Kurri Kurri Integrated Resource Recovery Centre

Response to Submissions Report

E230029 RP#23

March 2026

CWS Kurri Kurri Integrated Resource Recovery Centre Response to Submissions
Figure 4.1

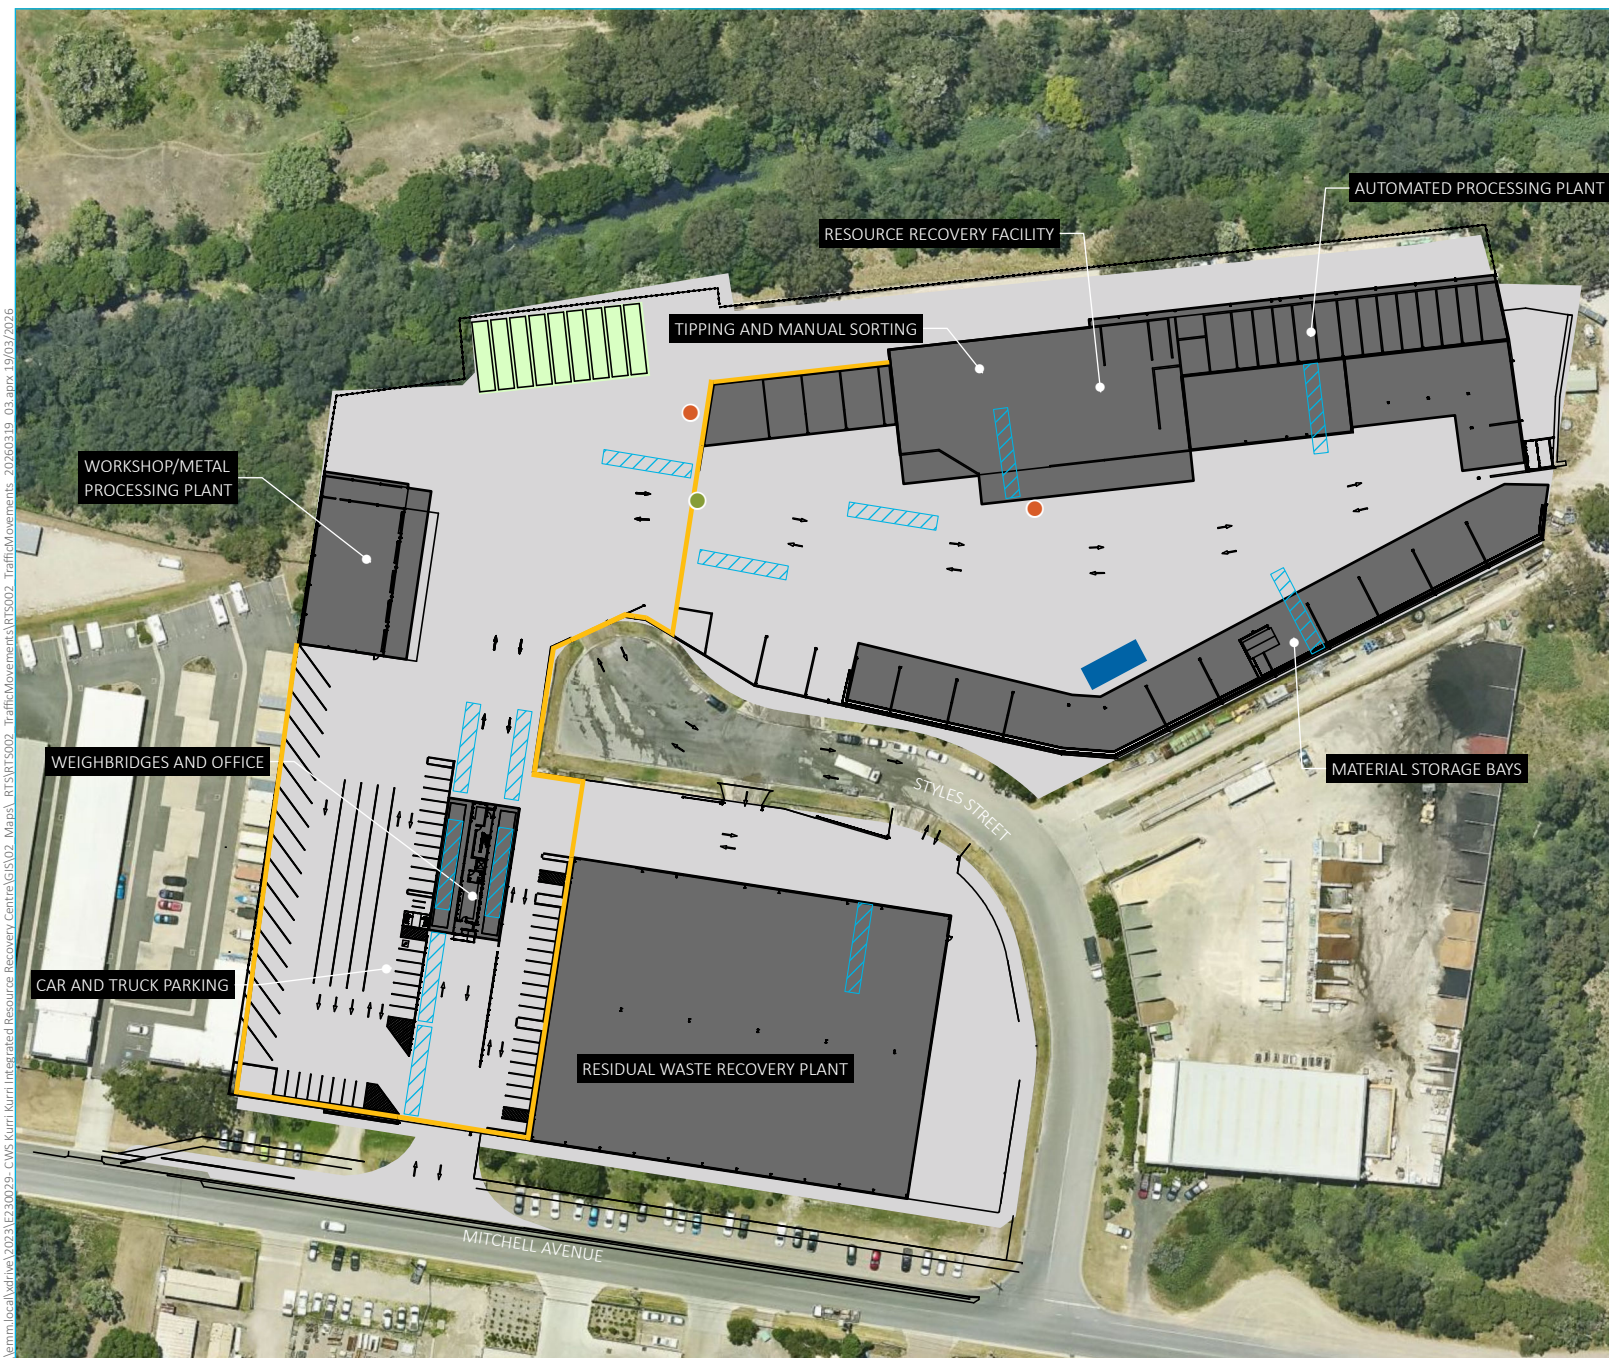
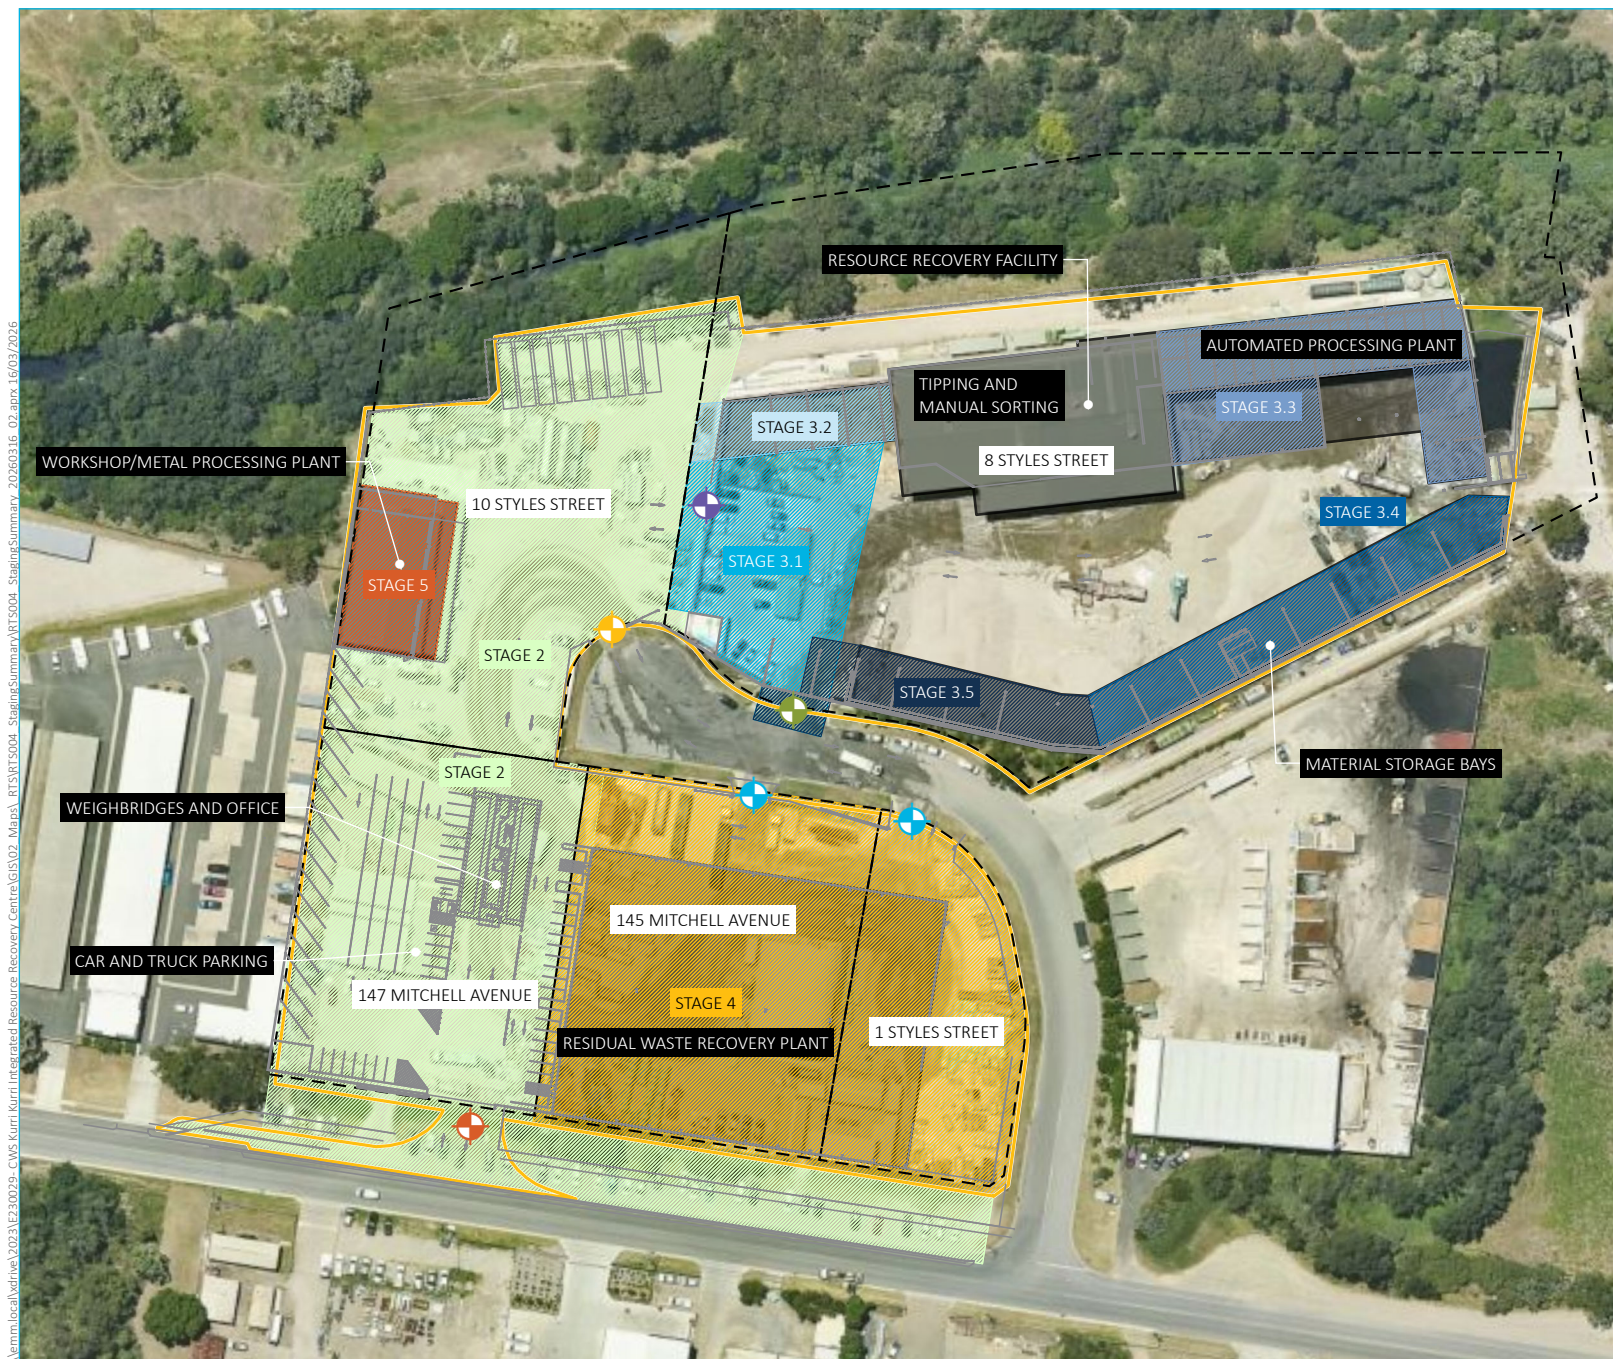
- detail measures to manage interactions between heavy vehicles, light vehicles, pedestrians and mobile plant, including separation, traffic controls and operational procedures

- provide updated site layout plans clearly illustrating internal traffic operations, including:

With an average on-site duration of approximately 15 minutes per truck, typically three to four trucks will be present on site at any one time. This level of activity can be readily accommodated within the site's internal circulation and queuing layout. Figure 4.1 illustrates a scenario with 13 trucks on site simultaneously, demonstrating that adequate space is available for safe vehicle manoeuvring during peak periods.

- **inbound weighbridge:** three 19 m semi-trailers can queue (one on the weighbridge, two downstream)
- **RRF entry:** space for semi-trailers to queue at the traffic lights before entering the operational area
- **internal holding area:** nine spaces in the north-west corner where trucks can wait until capacity becomes available
- **inspection area:** one semi-trailer can wait outside the receipt shed while another tips inside
- **loading/unloading bays:** trucks may temporarily hold within the loading/unloading bays while other vehicles or plant complete manoeuvres
- **outbound weighbridge:** space for one semi-trailer to queue prior to exiting.

Overall, the site can accommodate all inbound, internal, and outbound movements at peak throughput without queuing beyond the boundary. An example of 13 trucks on site, including vehicles occupying some of the queuing and waiting locations, is provided in Figure 4.1 to illustrate the available internal capacity.

Operational separation will be achieved through the following measures:

- Peak heavy vehicle movements do not coincide with peak arrivals and departures for staff (approximately 40 light vehicles).
- Light vehicles will not pass through the weighbridge.
- Light vehicles will not travel north of the weighbridge, where the majority of heavy vehicle activity will occur.

- Heavy vehicles will have right-of-way, as established in an Operational Traffic Management Plan.

Pedestrian movements will be managed via clearly marked pathways connecting the staff car park to operational areas. A pedestrian crossing at the RRF entry traffic lights will enable controlled access. A conceptual layout of the pedestrian walkways is shown in Figure 4.1 (subject to detailed design).

Figure 4.3 Example waste processing throughput and recovery rate at Stage 3 (without RWPR or metals processing)

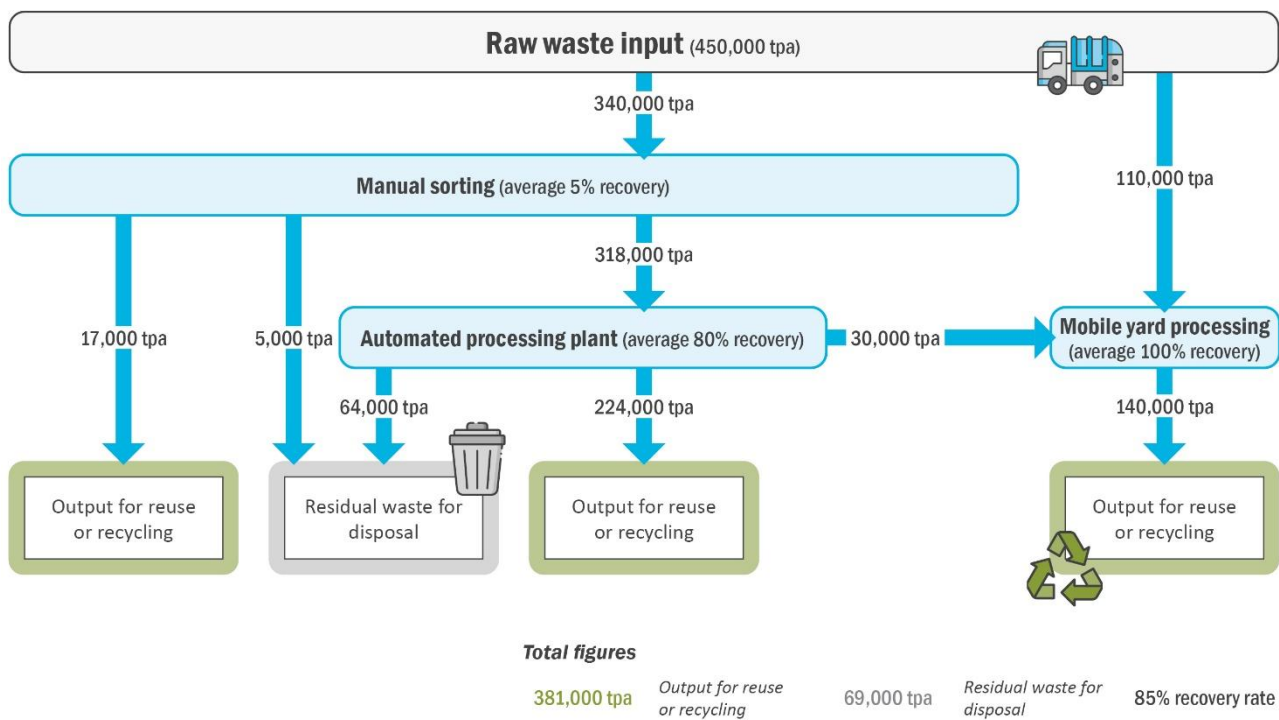
- clarification of how residual waste and recoverable metal materials will be stored, managed and/or processed during the interim period prior to commissioning of the RWRP and metal processing plant (Stages 4 and 5), given the proposed increase in throughput to 450,000 tpa by Stage 3

The IRRC has been staged to provide operational flexibility. By completion of Stage 3, all infrastructure required to receive, process, store and dispatch the maximum anticipated throughput of 450,000 tpa will be in place.

The existing automated processing plant has a capacity of 75 tonnes per hour, equating to approximately 336,000 tpa when operated for 16-hours per day, six days per week, over 50 weeks per year. When combined with manual pre-sorting and mobile yard processing, the IRRC is capable of achieving the maximum proposed throughput of 450,000 tpa without Stages 4 and 5 (refer to Figure 4.3).

Stages 4 and 5, comprising the RWRP and metals processing facilities, provide higher-value processing that improves product quality and marketability. However, these stages are not required to achieve either the maximum throughput or the facility's recovery targets.

Figure 4.4 Example waste processing throughput and recovery rate at Stage 5 (with RWPR and metals processing)

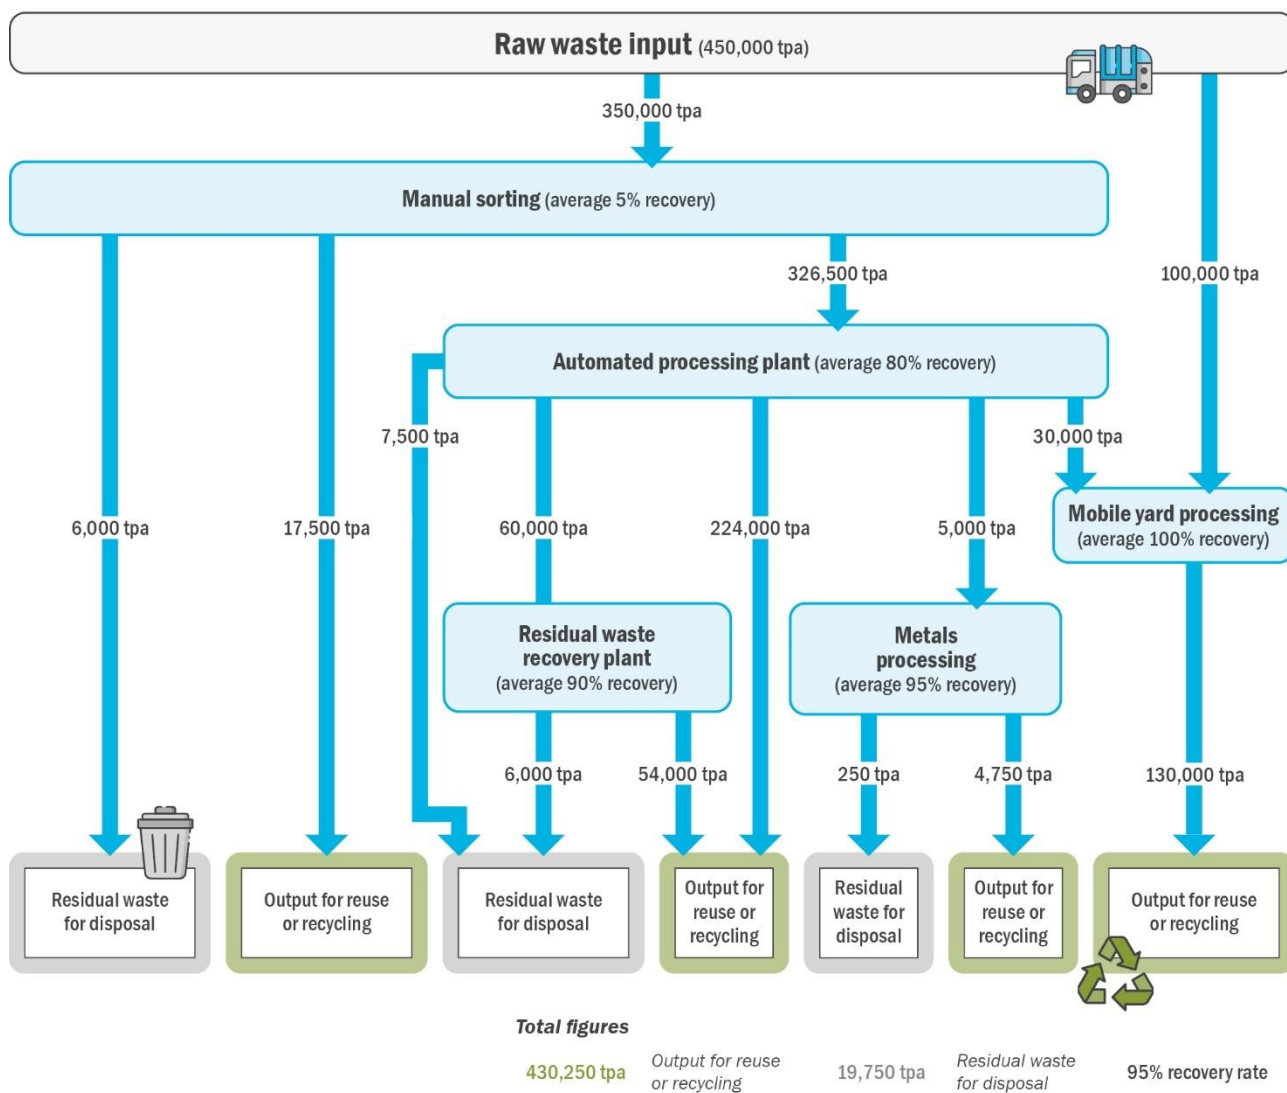
- justification that the proposed size and capacity of the RWRP are proportionate to the anticipated volume of residual waste generated by the automated processing plant after achieving the stated 85% resource recovery target

As noted in Section 6.1.2(ii) of the EIS, the existing automated processing plant has a capacity of 75 tonnes per hour, while the RWRP would have a capacity of approximately 13 tonnes per hour.

The RWRP is designed to undertake more refined processing than the existing automated processing plant. Accordingly, its size and building footprint are not directly proportional to throughput when compared with the automated processing plant. The building dimensions are driven by specific operational requirements, including the use of long, relatively flat conveyors and the incorporation of dedicated pelletisation and baling plant.

The proportion of waste processed through each of the five processing types, and the balance of recovered and residual material, will vary depending on the composition of incoming waste. The IRRC is designed to target an average recovery rate of approximately 85% across the operation as a whole. Figure 4.3 and Figure 4.4 demonstrate how both the proposed throughput and recovery rate can be achieved at Stage 3 and Stage 5, respectively.
